## RESPONSE TO REQUEST FOR ADDITIONAL INFORMATION

### APR1400 Design Certification

Docket No. 52-046

RAI No.: 167-8191  
SRP Section: 09.01.01 - Criticality Safety of Fresh and Spent Fuel Storage and Handling  
Application Section: Criticality analysis TeR Section 3.4  
Date of RAI Issue: 08/20/2015

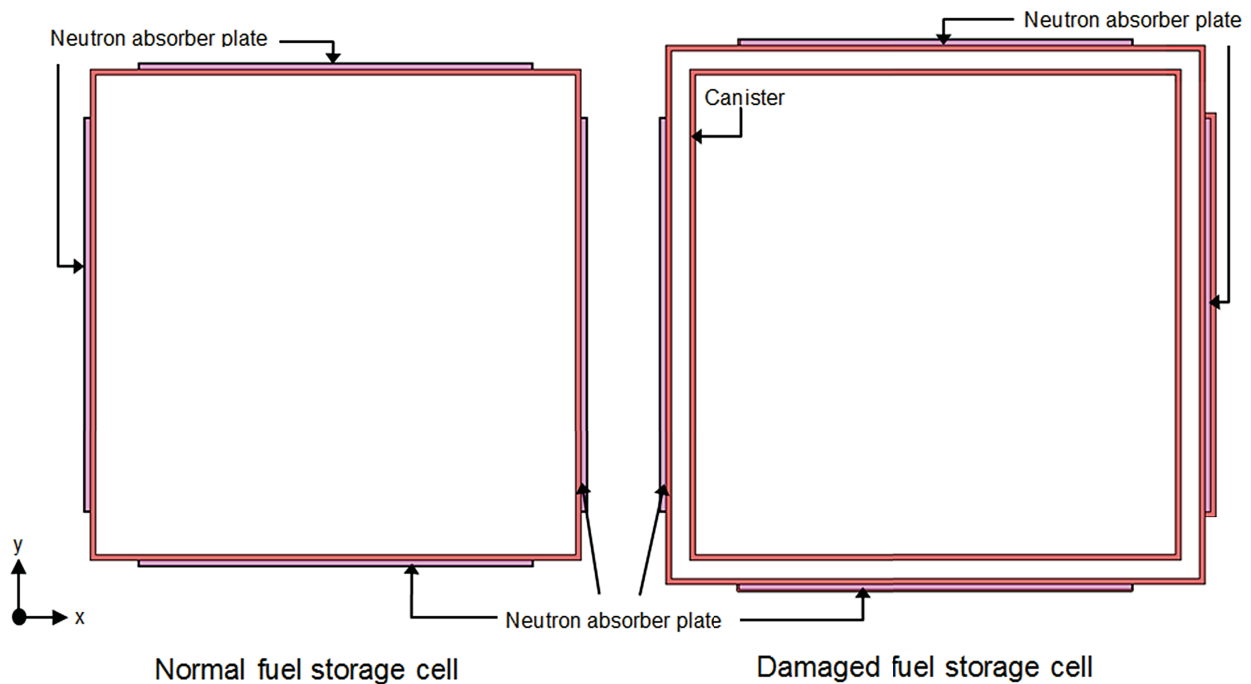
In Figure 3.4-3 of the criticality analysis report, it appears that not all cells along the outer walls of the racks in spent fuel pool region I have absorber plates facing the outer walls. It is therefore not clear that the infinite-array model shown in Figure 3.4-1 is conservative with regard to the finite-array effects of local moderation and reflection along the outer walls of the region I racks. In particular, the staff is concerned that the reactivity-increasing spectral effects of enhanced local neutron moderation and local thermalizing reflection in rack cells without absorber plates at their outer walls could in this case eventually prove to outweigh the reactivity-lowering leakage effects in the finite-array model such that the applicant's infinite array reference model can no longer be seen as conservative.

Four neutron absorber plates are attached to the four faces of each fuel storage cell in the spent fuel pool (SFP) region I as shown in the picture below. So, all cells along the outer walls of the racks have neutron absorber plates facing the outer walls. To clarify the analysis models, Figures 3.4-2 and 3.4-3 of the criticality analysis technical report will be replaced with high resolution figures.

Because of the existence of neutron absorber plates facing the outer wall, the finite-array effects of local moderation and reflection along the outer walls of the region I racks are negligible. Therefore, the infinite-array model applied to the criticality analysis technical report is a conservative assumption.
